RE: ERAU Fitness Complex - Prebid RFI Responses  
**Project Number: 20-001**  
RFIs #001- 045

The following narrative lists the responses to the Prebid RFIs submitted during the bid phase of the ERAU Fitness Complex project. Following each question is the Design Team response.

PROJECT:  
ERAU FITNESS COMPLEX

**SKA-1**

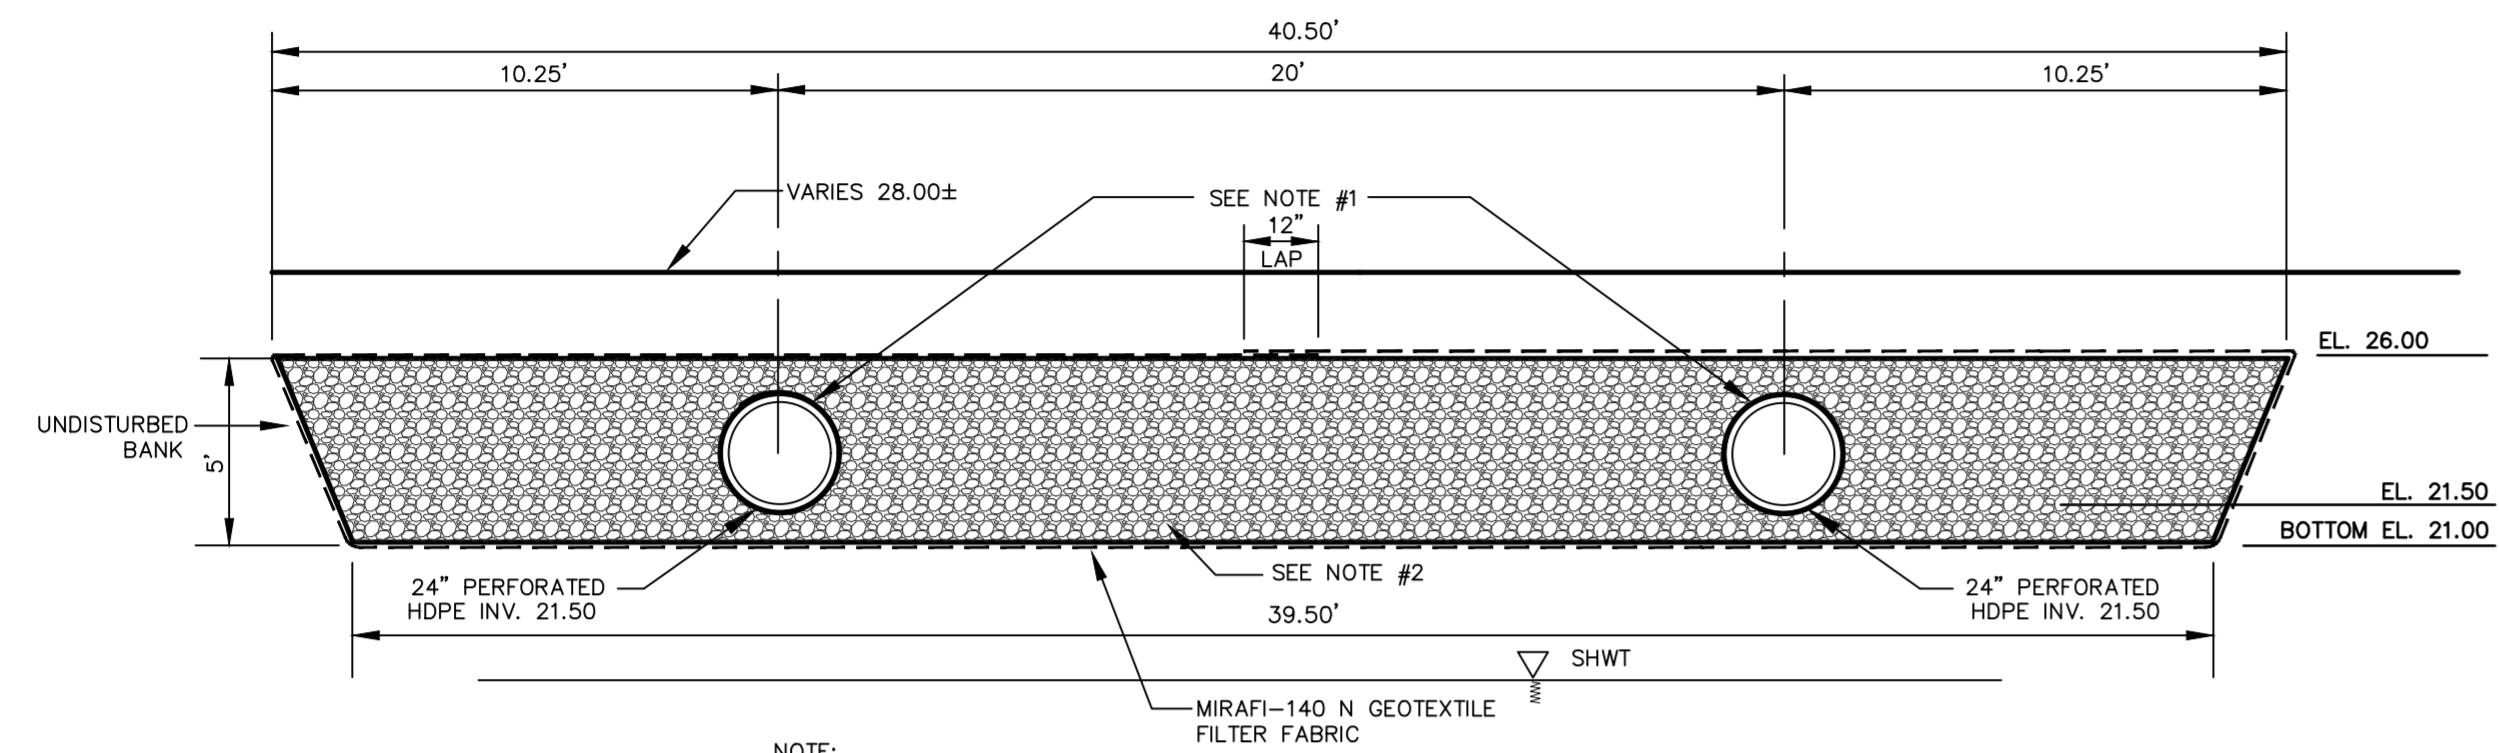
- 1) Window details on A2.210 & A2.211 and Door Details G2.102 & G2.103 are not referenced on any of the door types, schedules, or elevations. Please provide section details for each of the storefronts, curtain walls and doors so we know what headers and jambs are required for every door, storefront and curtain wall.

**Response: Typo, 44 lockers is correct.**
- 17) Please provide details and door type information for doors 110E, 110P, 110R, 114E, as it is not on the G2.101 Door Schedule.

**Response: See updated door schedule attached SKA-01.**
- 18) Door 109A has no door type. Please provide.  
**Response: See updated door schedule attached SKA-01.**

**Response: Door details have been added to the door schedule; see attached SKA-01. The details on A2.210 are labeled identifying at which conditions they occur.**

DEV 2020-009  
 CITY APPROVAL STAMP  
**11A**  
 SHEET NO.  
 Drawn By: MRB  
 Date: 01/15/2020  
 SCALE: NONE  
 JOB#: 19-40

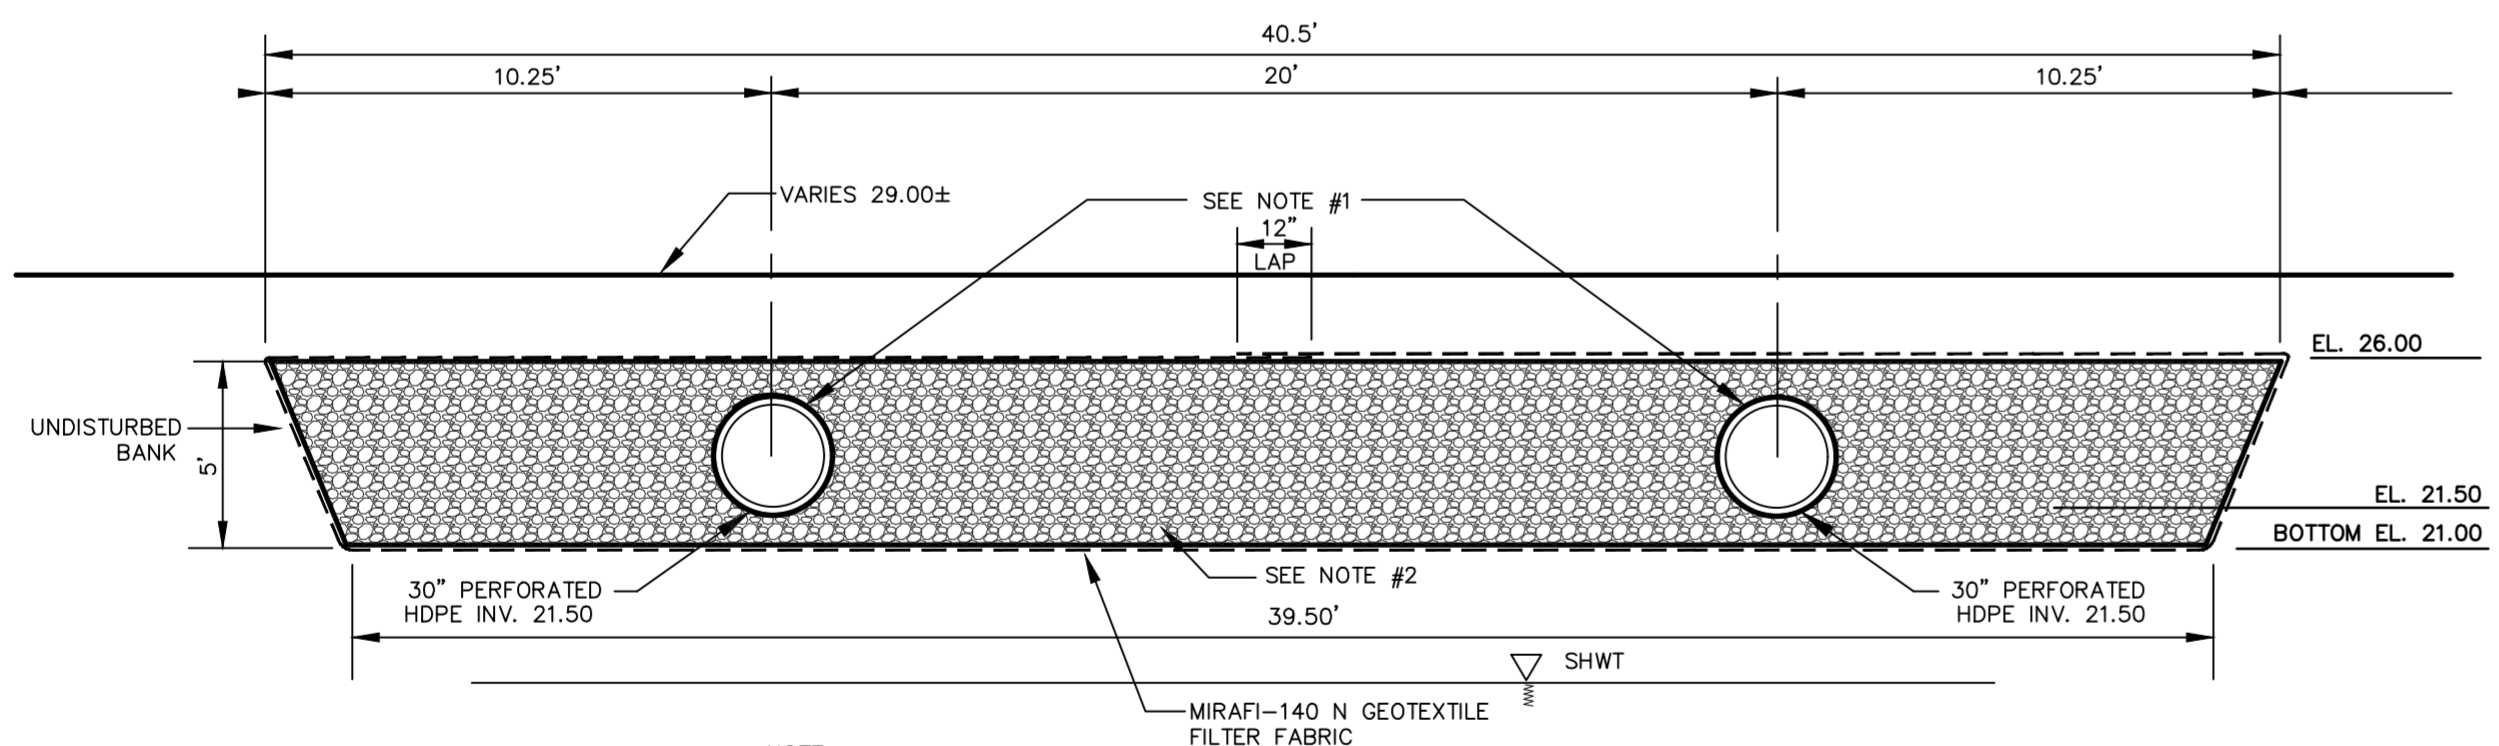
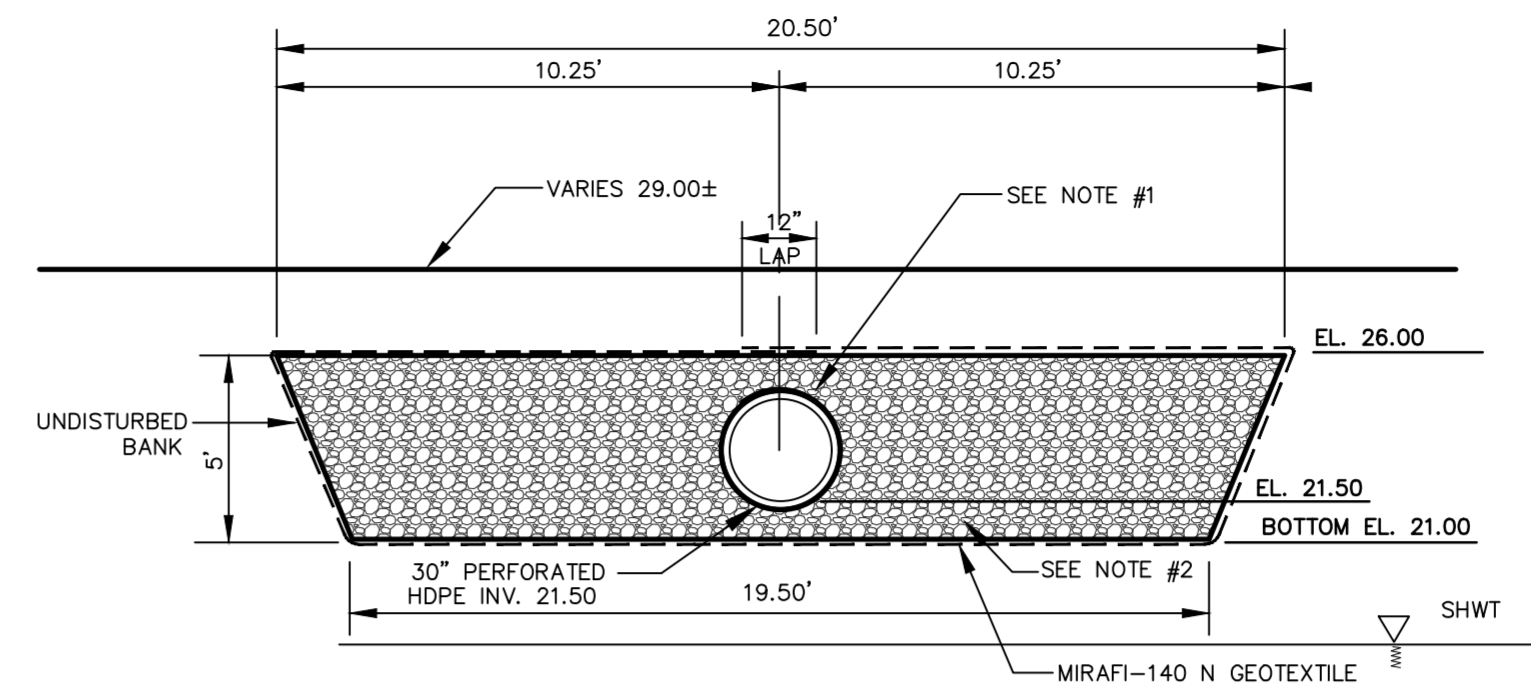
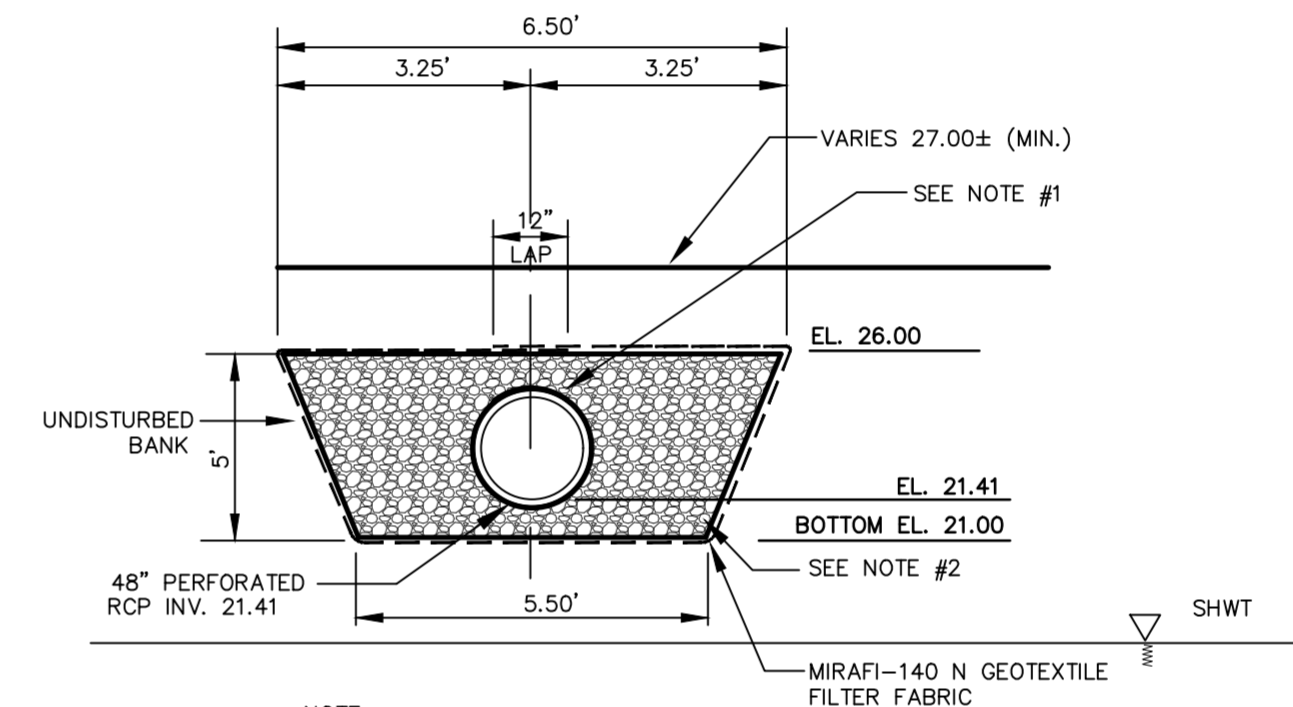
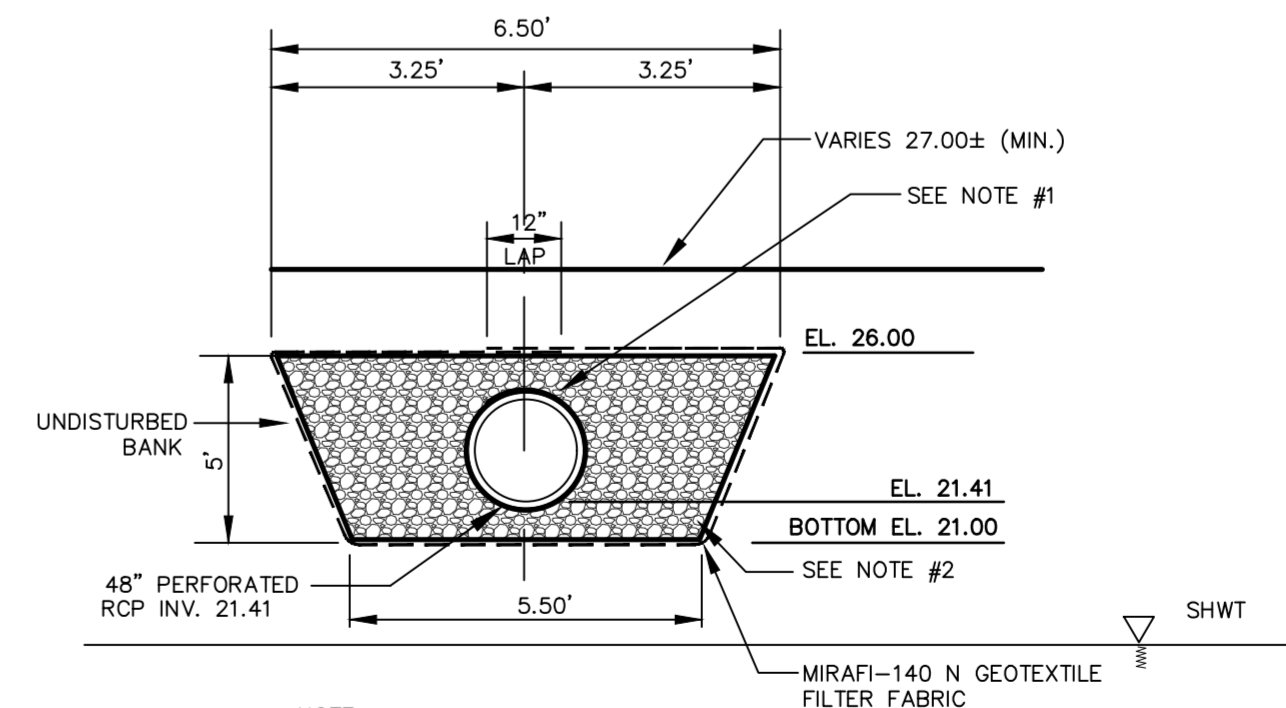
- 36) Drawing L1.101 shows additional trees to be saved from Civil Drawing #3. Which drawing is correct?  
**Response: Utilize sheet L1.101.**
- 37) Please provide a sectional detail of the existing rock trench.

**Response: See attached civil sheet 11A from the ERAU Dorm project showing the trench detail. As noted on the civil documents, (ESW) this work is being handled outside of this project scope.**
